MAS003383 RU 22-02

RAPID UPDATE 573

Rapid Update 573 MC20 Seat Rattle Noise

DATE: DECEMBER 14 2022

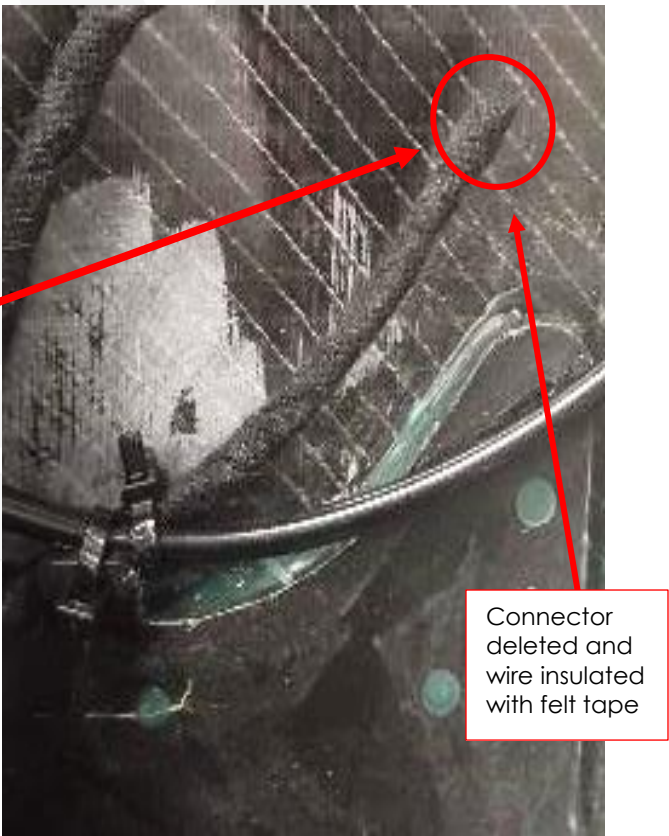
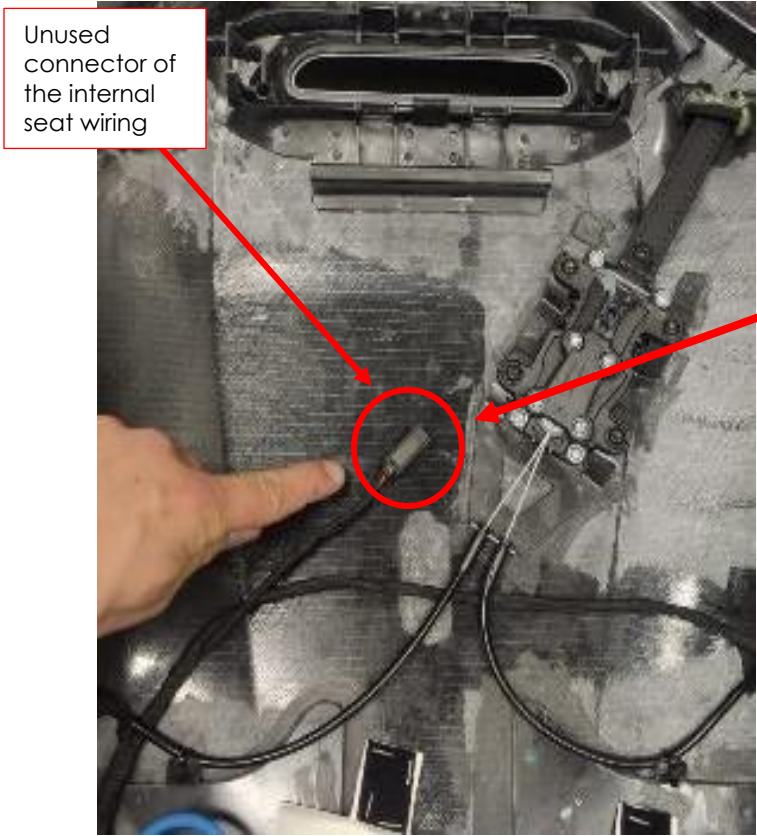
This action is needed to eliminate the source of the noise. MC20's without heated seats, are equipped with an unused connector included with the internal seats wiring harness. This connector, in some cases, could shake hitting the shell, creating the reported noise. To prevent this, the connector must be deleted by cutting it off from the harness.

5. Identify the unused connector and cut it off by cutting the wire just below the connector and removing it, as shown below.

Make sure that the wire is cut clean with no copper wire exposed from the wire insulation!

6. After the cut, insulate the wire harness using wire insulating felt tape.
7. Refit the passenger seat seatback upper carter.

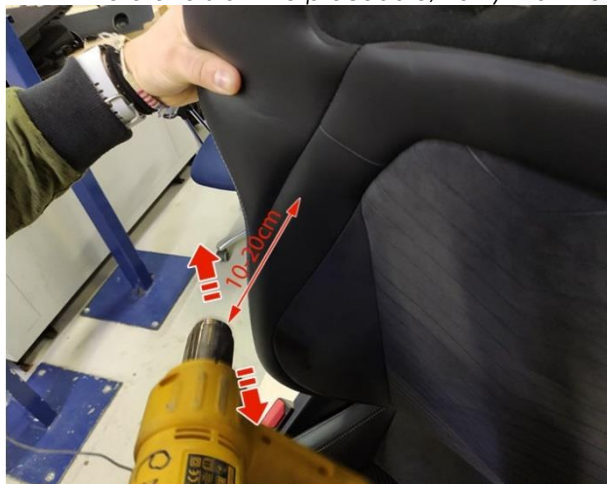
If during the operation there should be wrinkles on the leather of the seat, it is possible to eliminate them using a heat gun and smoothing the surface with a smooth spatula.

- Keep the gun at a distance of at least 10-20 cm;
- Never linger on the same point with the gun to avoid damaging the leather;
- Before to start the procedure, verify that the spatula doesn't present burr.
